X 86.105-26

281 MODEL

NEW FRONT HANDLE (wrap around handle)

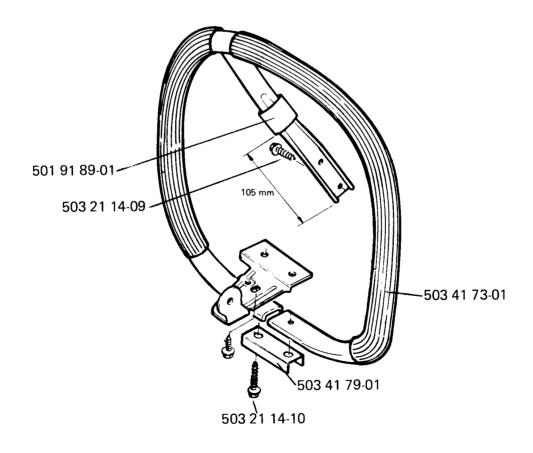
A new front handle more adjusted for the model 281 is now available.

The front handle 503 41 73-01 can not be assembled on the model 181 without making a recess in the crankcase.
